CLARIFICATION MEMO

To: ACT Participants & ACT Participating Tracks
From: ACT
Date: January 11, 2018
Subj: Chassis

2018 New London-Waterford Speedbowl

ACT Late Model Rules

Exhibit 3: Full Perimeter Chassis

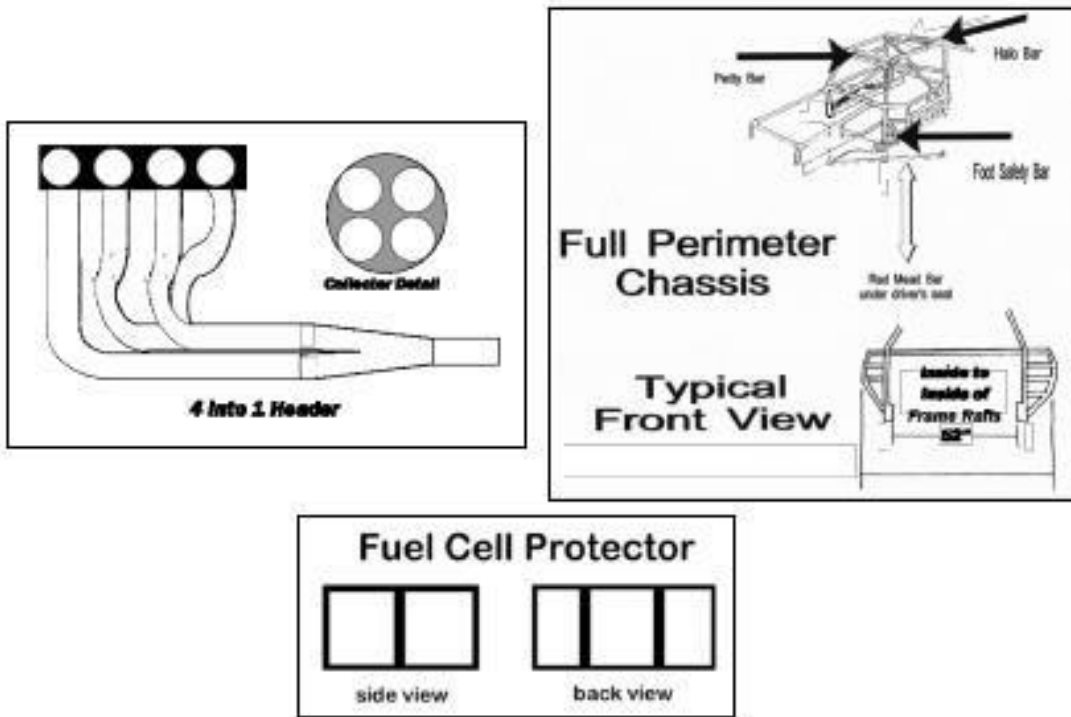
- Centerline of engine must remain within $\frac{1}{2}$ " (1/2 inch) measurement of centerline of tread width, measured from the inner pivot point of equal length front lower control arms on both sides of snout. A-frame suspensions will be measured from lower ball joints.

CHASSIS NOTCHING

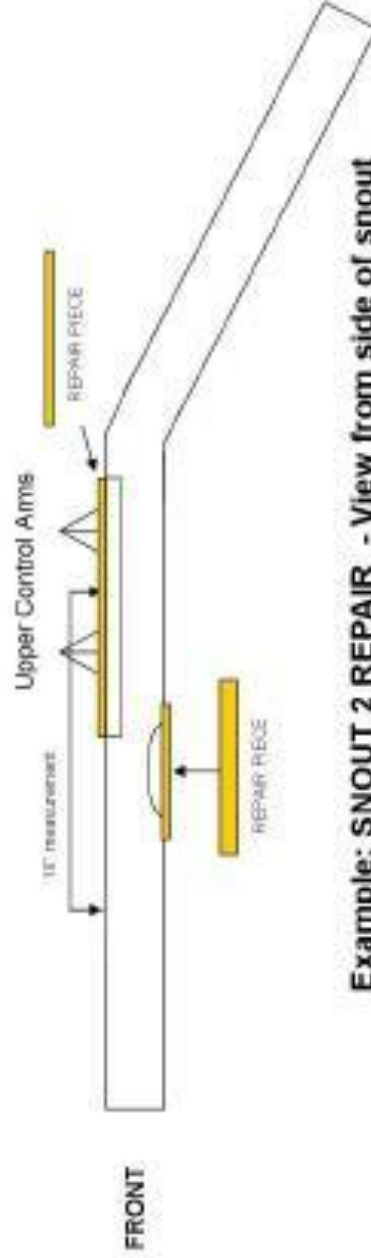
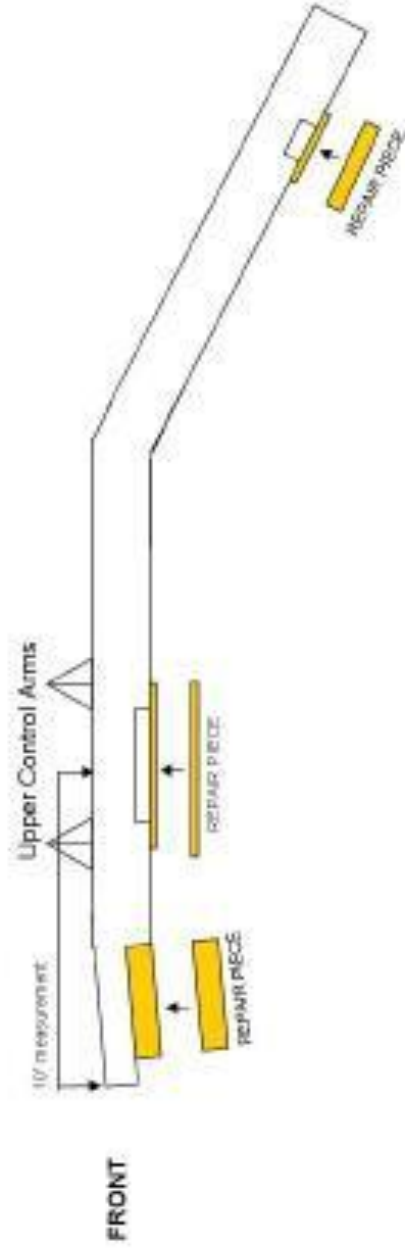
Teams MUST comply with 2 x 3 perimeter tubing rule. ACT approved fix for known issues are as follows:

Colored pieces indicate the position of approved known repairs to comply with ACT rules.

Example: SNOOT 1 REPAIR – View from side of snout

Example: SNOOT 2 REPAIR - View from side of snout
